City of Fenton  
 Old Highway 141 Bridge Value Engineering Proposal  
 Final VE Quantities  
 3/29/2011

**OLD HIGHWAY 141  
ROADWAY IMPROVEMENT PLANS**  
FENTON, MISSOURI  
Prepared For:  
**CITY OF FENTON**

**Re: Value Engineering of Fenton Creek Bridge Replacement  
Project No. BRM-4989(606), Bridge No. 1420013  
Response to Review Comments and Revised Final Plans**

OLD HIGHWAY 141  
 BRIDGE OVER  
 FENTON CREEK  
 DETAILS OF END BENT 2  
 SHEET 2 OF 3

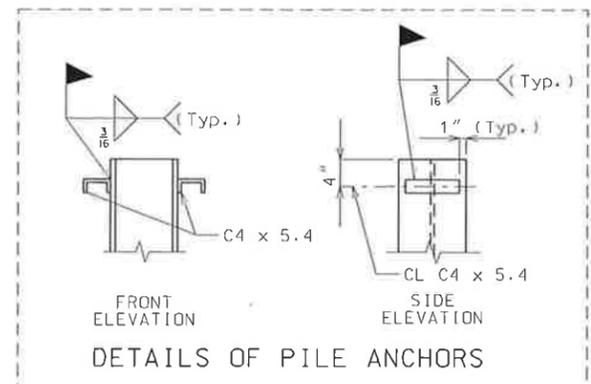
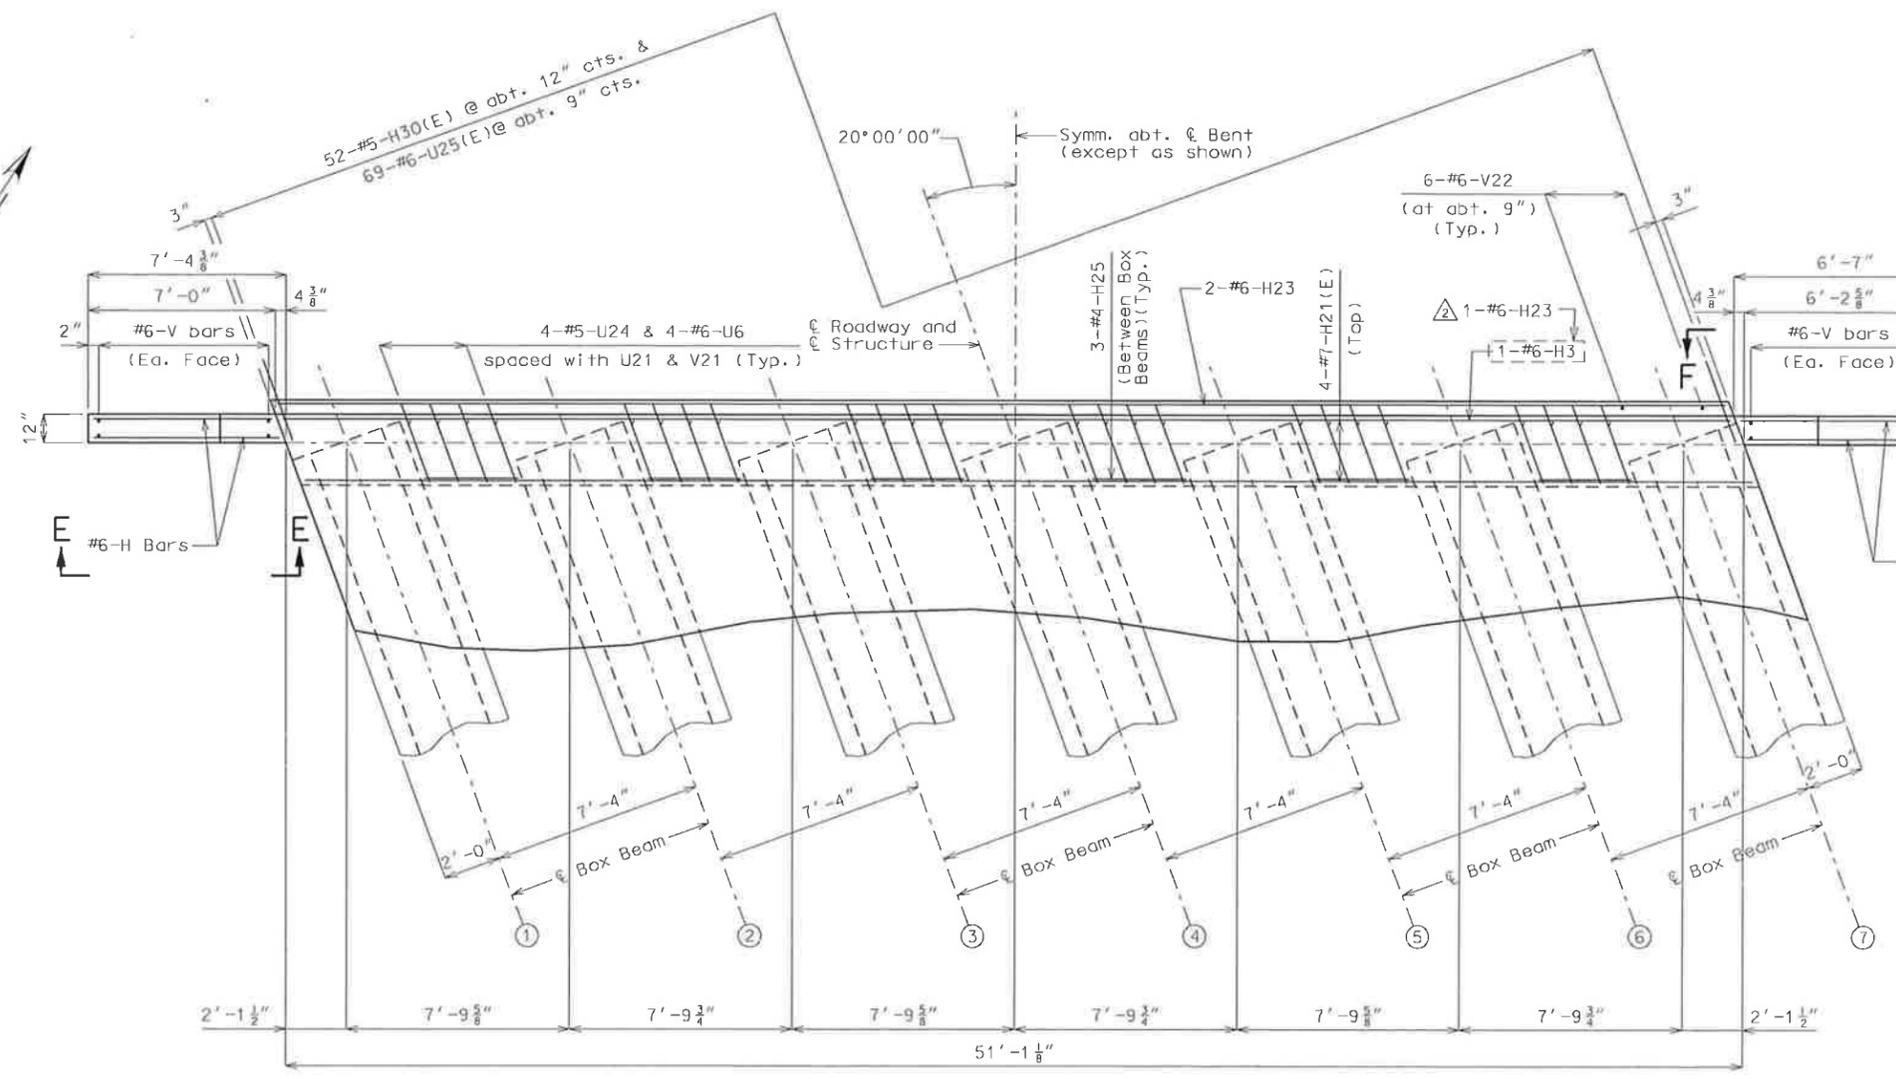
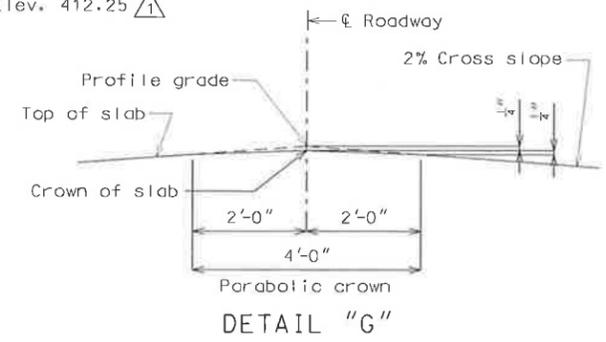
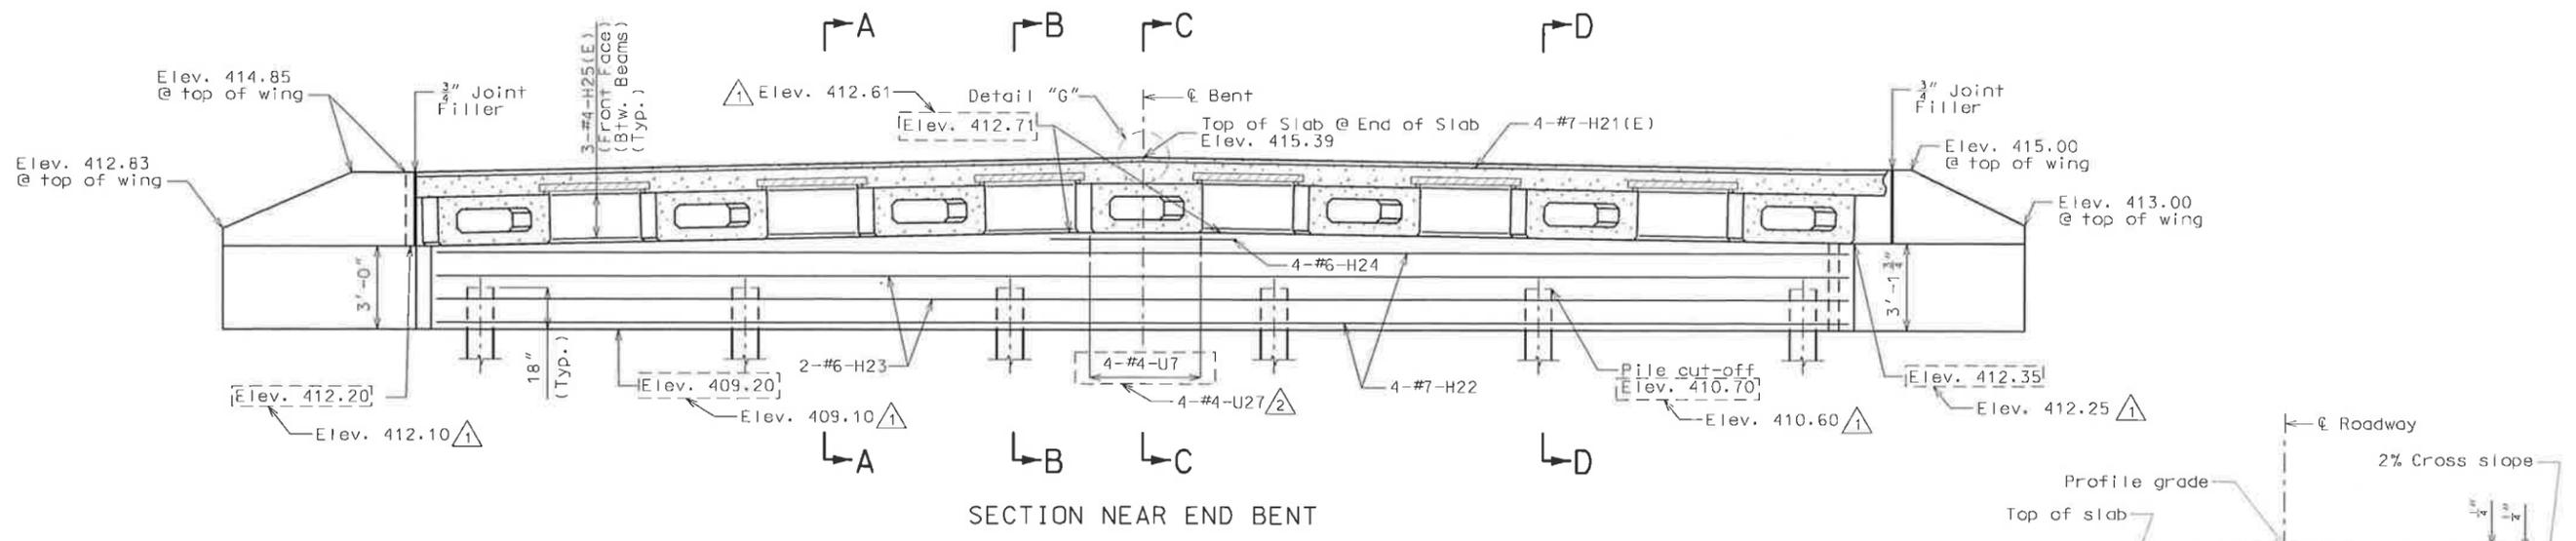
34. Revise callout to read 4-#4-U27 instead of 4-#4-U7 in SECTION NEAR END BENT. **Plans revised accordingly.**
35. Revise callout to read 1-#6-H23 instead of 1-#6-H3 in PART PLAN. **Plans revised accordingly.**
36. Add MoDOT Standard detail showing channel shear connectors for piles (see comment No. 11 above). **Plans revised accordingly.**

OLD HIGHWAY 141  
BRIDGE OVER  
FENTON CREEK  
DETAILS OF END BENT 2  
SHEET 3 OF 3

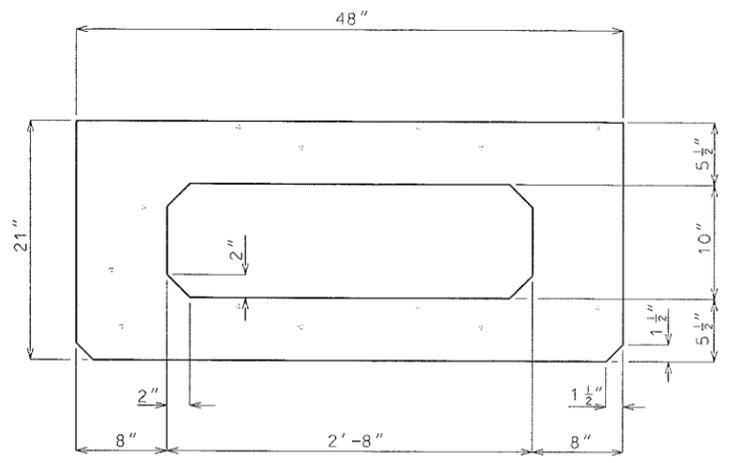
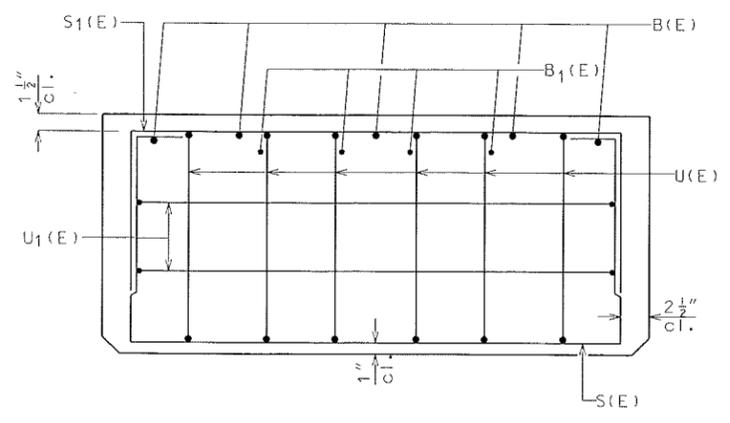
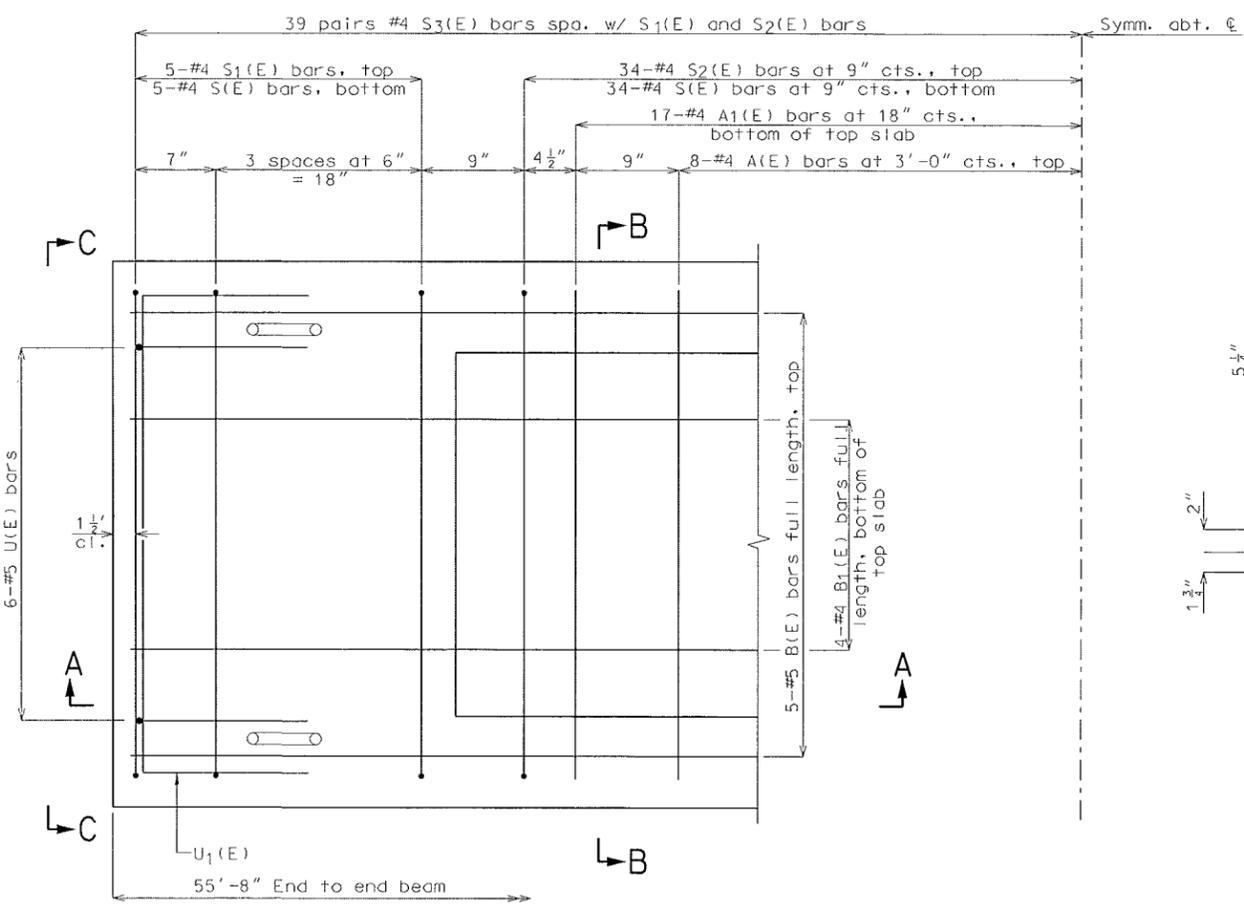
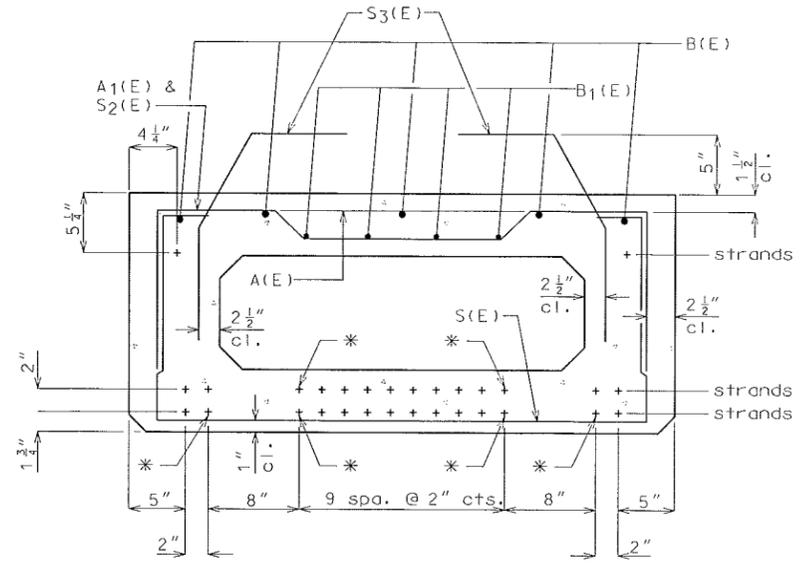
37. Revise Elevation callout at bottom of beam to read *Elev. 409.10* in SECTION B-B. **Plans revised accordingly.**

38. Revise bar callout to read #4-U27 instead of #4-U7 in SECTION C-C. **Plans revised accordingly.**

OLD HIGHWAY 141  
BRIDGE OVER  
FENTON CREEK  
DETAILS OF PRECAST  
PRESTRESSED 48" BOX BEAMS  
SHEET 1 OF 2

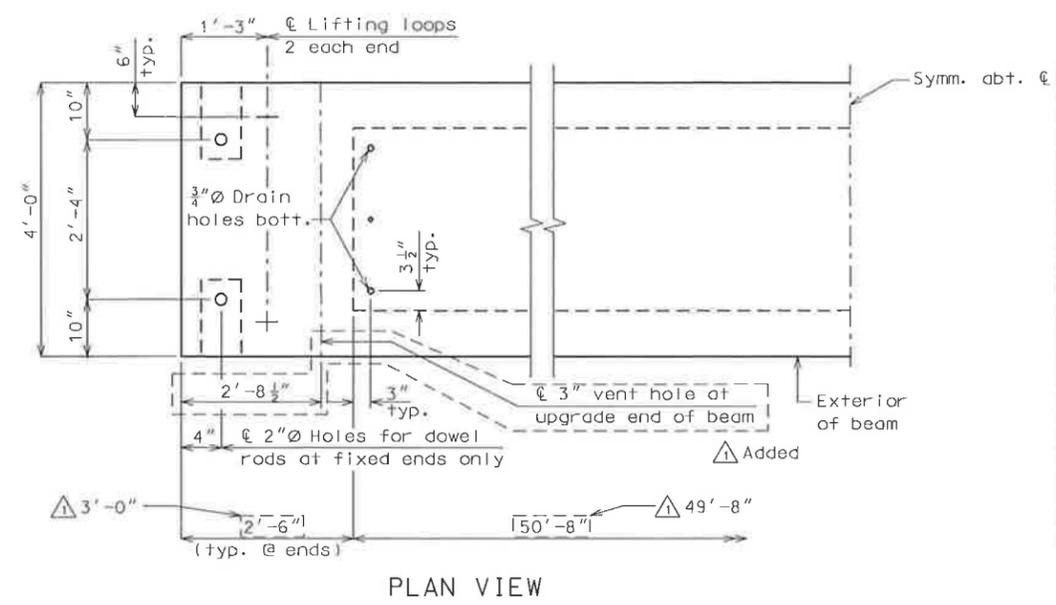
39. Is there some way to provide a 3" diameter vent hole at or near the upgrade 1/3 point of the beams similar to that shown in EPG Section 751.22.3.16 for P/S I-girders? We do not want to fill the voids in the beams with water but could the vent hole be sleeved with PVC or other to permit trapped air between the box beams to escape as water rises above the beams and remain water tight? Vent holes were not needed with adjacent box beams but the VE redesign provides spread boxes. This bridge will be overtopped as indicated in the Hydrologic Data Table on Sheet B-2 of the original Woolpert plans. **A 3" vent hole was added thru the solid section of the box near the upgrade end and the void length was modified to accommodate this.**

HALF SECTION NEAR Q SPAN

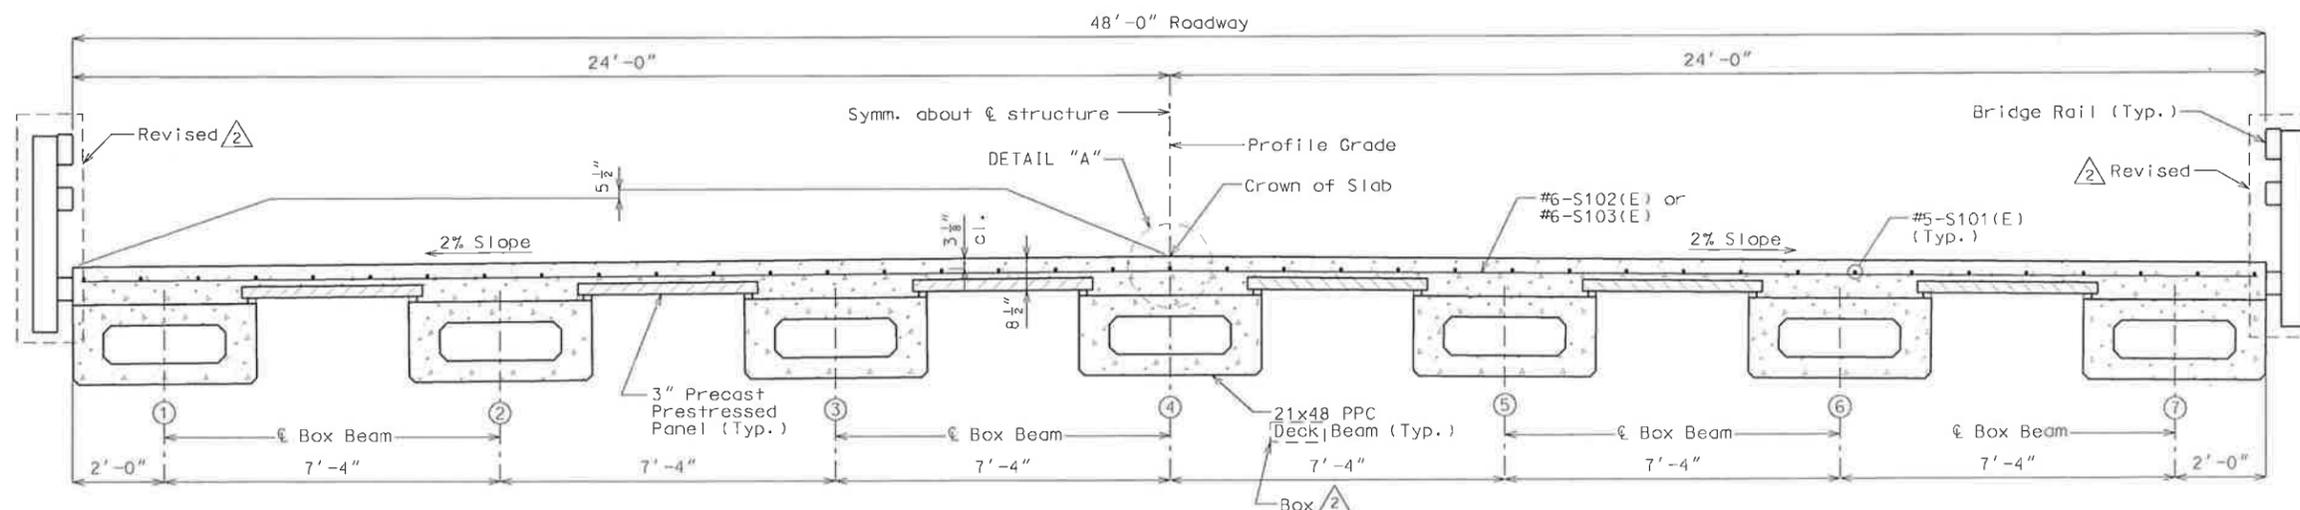
42. Revise callout in HALF SECTION NEAR CENTERLINE SPAN to state *21x48 PPC Box Beam (Typ.)* instead of *Deck Beam*. **Plans revised accordingly.**

OLD HIGHWAY 141  
BRIDGE OVER  
FENTON CREEK  
DETAILS OF GUARDRAIL  
SHEET 1 OF 2

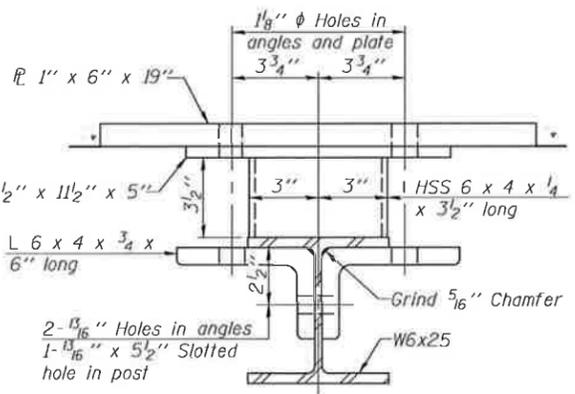
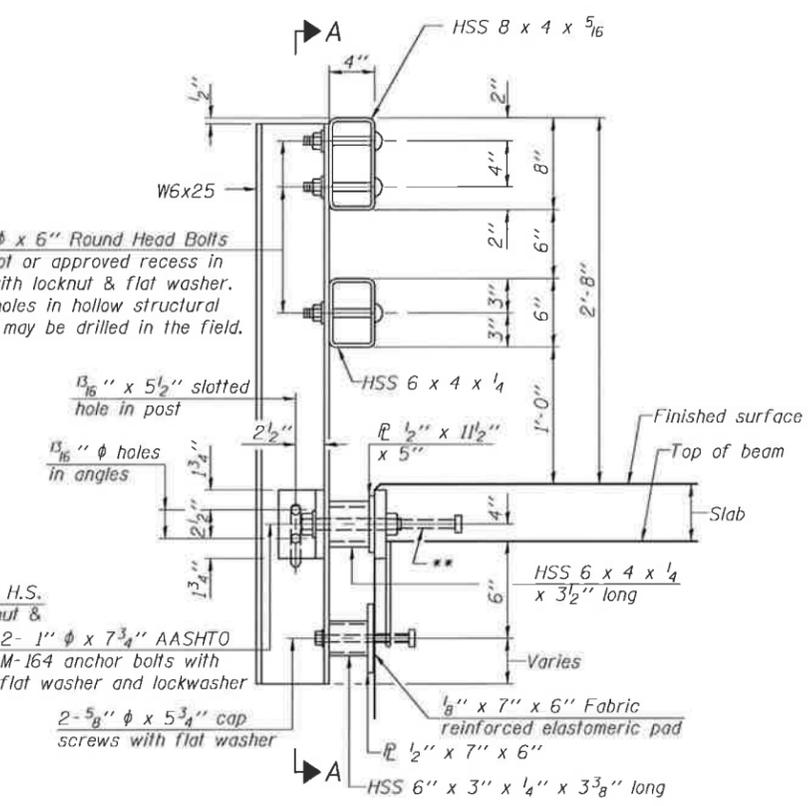
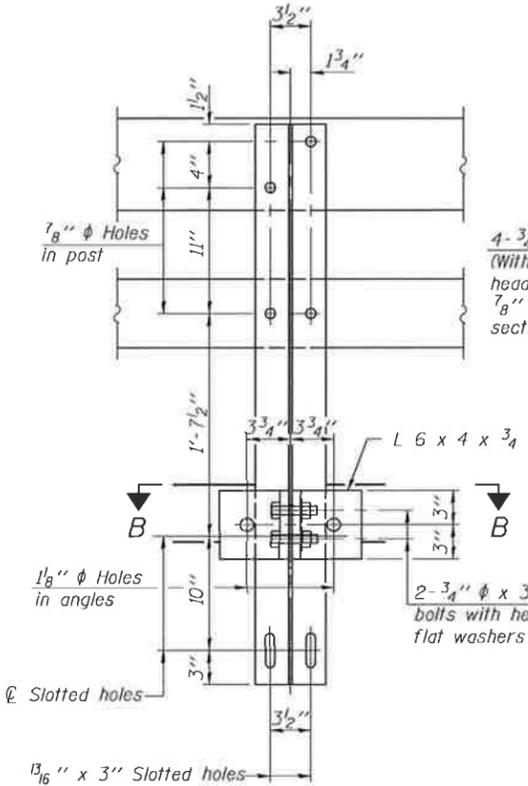
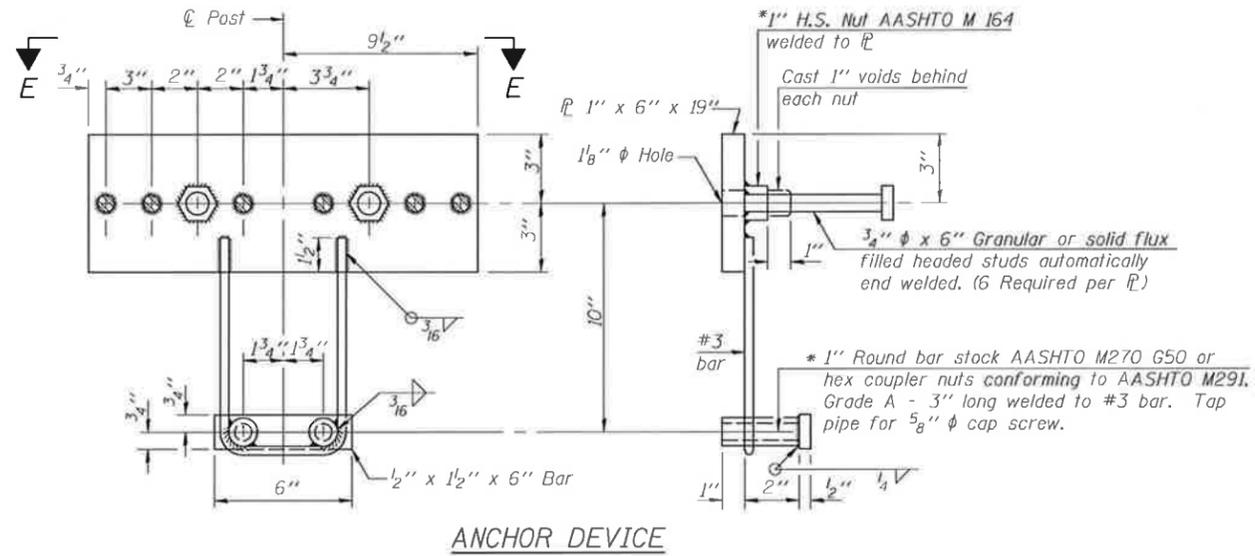
25. Verify that location of 1" diameter x 7 ¾" AASHTO M164 Anchor Bolts shown 6" below top of beam in SECTION AT RAIL POST will work with P/S strands shown 5 ¼" below top of beam in SECTION B-B on Sheet No. 12. It appears that the anchor bolts and P/S strands may conflict. **There is approximately 1.5" clearance to the strands which is adequate.**
26. Revise note at bottom left that refers to "5" minimum to 7 1/8" maximum CWS thickness". The CWS (concrete slab) thickness provided is 8½". **Note was revised.**
